CITY COUNCIL STAFF REPORT

DATE: January 7, 2015

SUBJECT: WEST COAST HOUSING PARTNERS ON BEHALF OF THE OWNER; THE ERIC BRANDENBURG SEPARATE PROPERTY TRUST FOR APPROVAL OF A PRELIMINARY AND FINAL PLANNED DEVELOPMENT DISTRICT IN LIEU OF A CHANGE OF ZONE, A CONDITIONAL USE PERMIT FOR CONDOMINIUM USES IN THE RESORT COMBINING ZONE, A MAJOR ARCHITECTURAL APPLICATION, AND A TENTATIVE TRACT MAP FOR CONDOMINIUM PURPOSES FOR DEVELOPMENT OF 46 TWO-STORY, DETACHED RESIDENTIAL UNITS ON ROUGHLY 5.23 ACRES AT THE SOUTHEAST CORNER OF NORTH PALM CANYON DRIVE AND ALVARADO ROAD (CASE 5.1340 PDD 370 CUP, 3.3742 MAJ, TTM 36725) (ZONE C-1 / RGA-6 / R-3 / RESORT COMBINING ZONE). (APN's 504-074-001, 002 & 008) (KL)

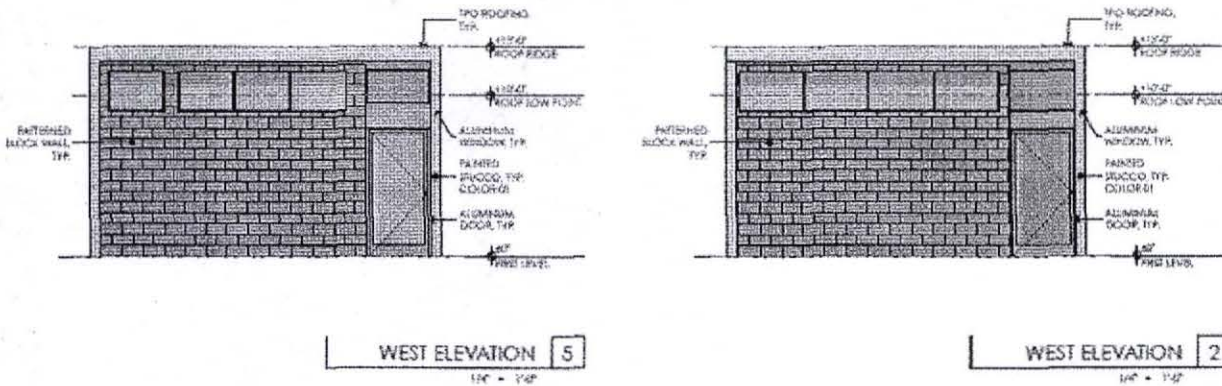
2. *Revise the site concept to provide better accommodation for pedestrian circulation within the project to provide sidewalks along one side of the streets or by other creative means, taking into consideration workmen and guests as well as residents. (Staff note: Reference PSZC 94.04 Architectural Review guideline D.1 which notes, "...Definition of pedestrian and vehicular areas; i.e. sidewalks as distinct from parking lot areas;" (e.g. vehicular travelways) and note additional PC comment #14 below on paving differentiation)*

Staff evaluation: Not resolved. The applicant has proposed changing the pavement of the private streets from asphalt to pre-cast brick pavers, however no accommodation for separation of pedestrian and vehicular circulation is proposed and no distinct pavement color or pattern is proposed to demarcate the pedestrian walkway from the vehicular travelway. A condition of approval has been proposed requiring either that separate sidewalks be provided, or the streets be revised to conform to the General Plan in terms of width with a provision that visual or physical delineation and separation of vehicular and pedestrian travelways be created within the project.

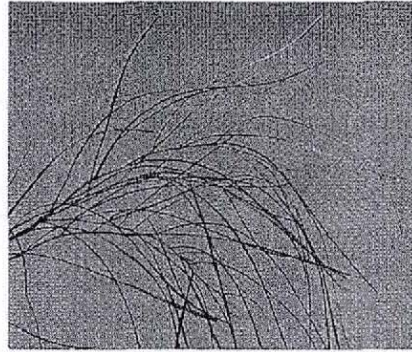
5. Provide 48 inch minimum box size for shade trees as shown on the landscape plan at the corner oasis. Select species suitable for the windy conditions at the site in lieu of structures for shade at that corner and provide more individual seating.

Staff Evaluation: Not resolved. More stones for seating have been proposed. Tree species and sizes proposed at the corner park are 24 inch box Acacia Aneura (Texas Olive), 24 inch box Acacia Salicina (Shoestring Acacia) and 36-48 inch box Tipu Tree (a species of palo verde). Staff's concern with shoestring acacia is that its thin "stringlike" leaf affords little to no shade protection. A condition of approval is proposed requiring all shade trees in the corner oasis be 48 inch box trees and an alternative species instead of the shoestring acacia be proposed with greater shade capability.
